**Amendments to the Drawings**

**REMARKS**

This Amendment is in response to the Office Action mailed on May 26, 2005. The Applicants amended drawing figure 3C to correct a reference numeral. Specifically, the second (lower) instance of "J1" is corrected to read "J2". Support for this correction may be found in paragraph (0050), on page 12, of the application as-filed.

FIG. 3C

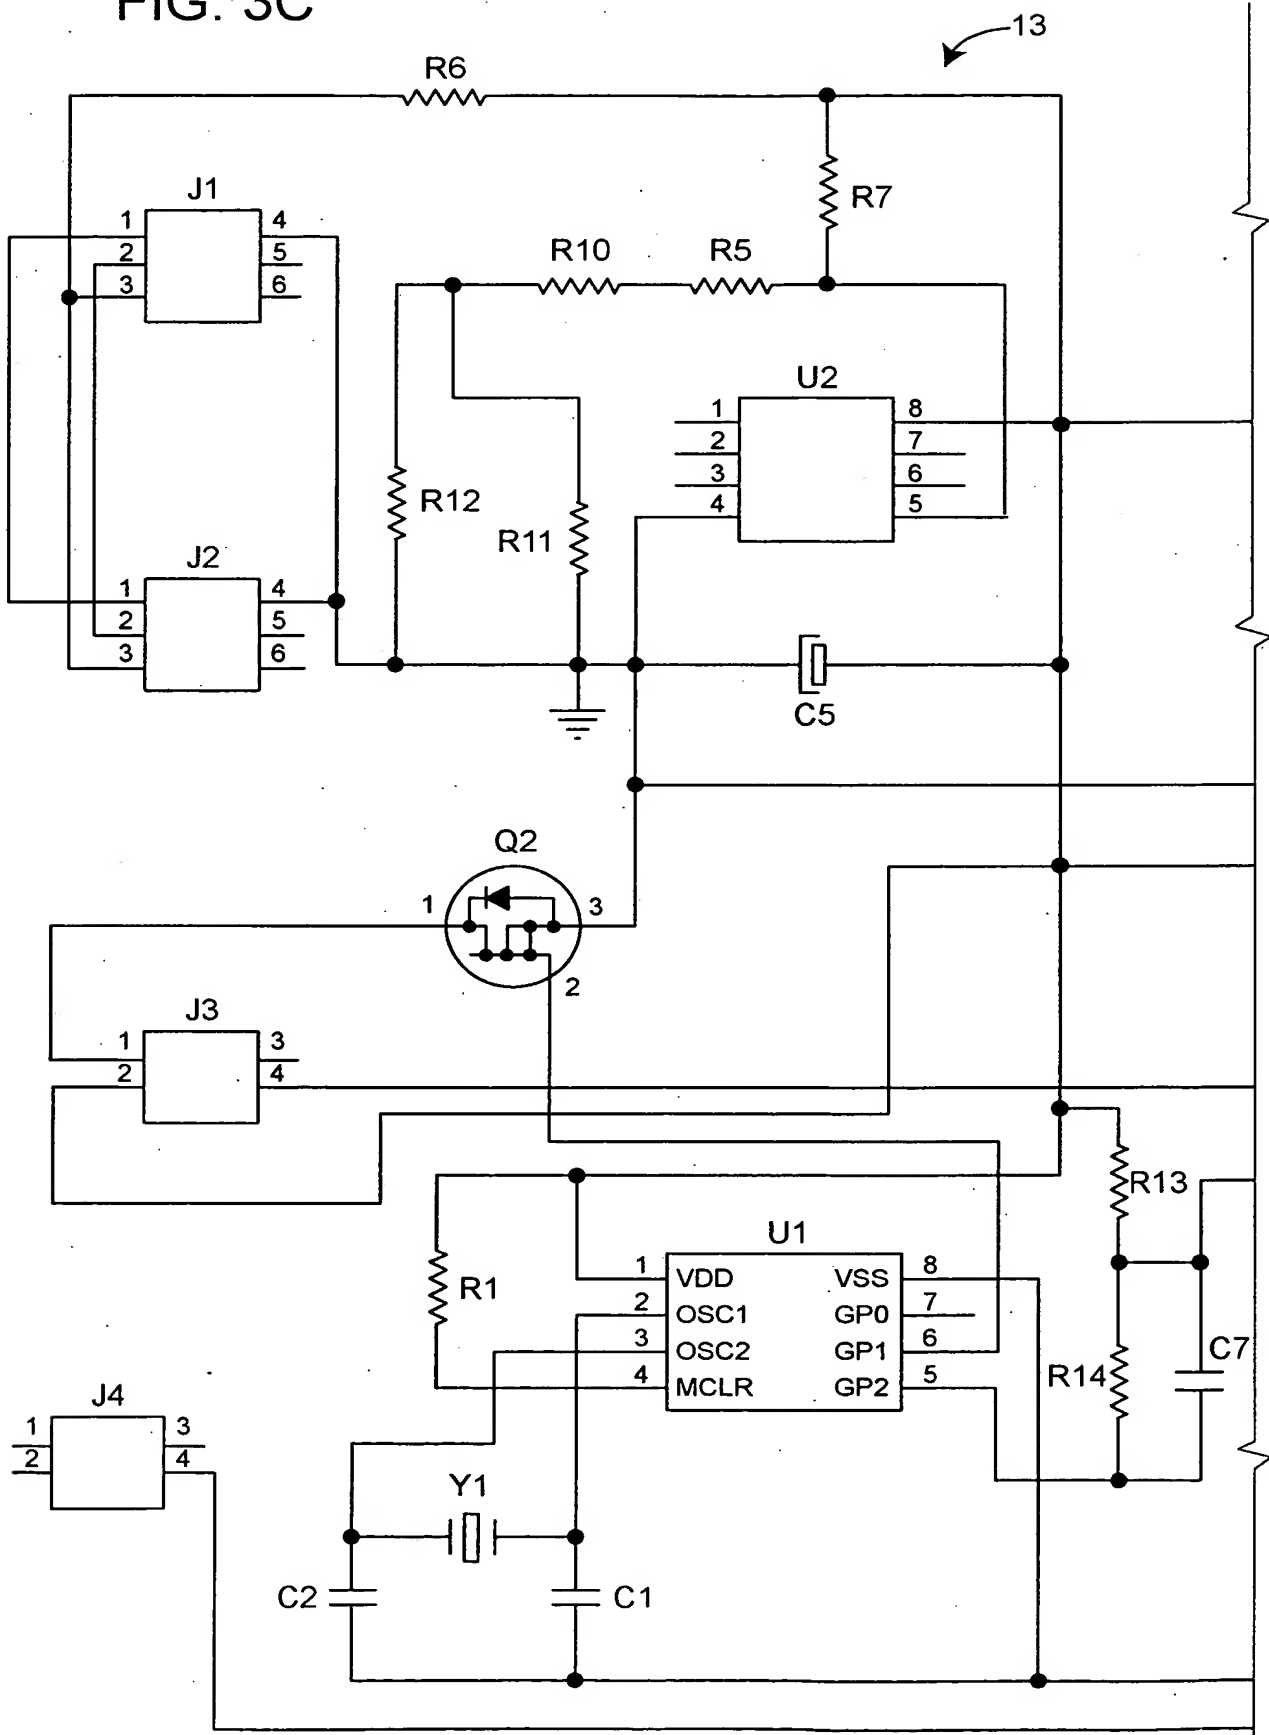
The attached sheet of drawings includes changes to Fig. 3C. This sheet, which includes Fig. 3C, replaces the original sheet including Fig. 3C. In Fig. 3C, the second (lower) occurrence of reference numeral "J1" is corrected to read "J2".
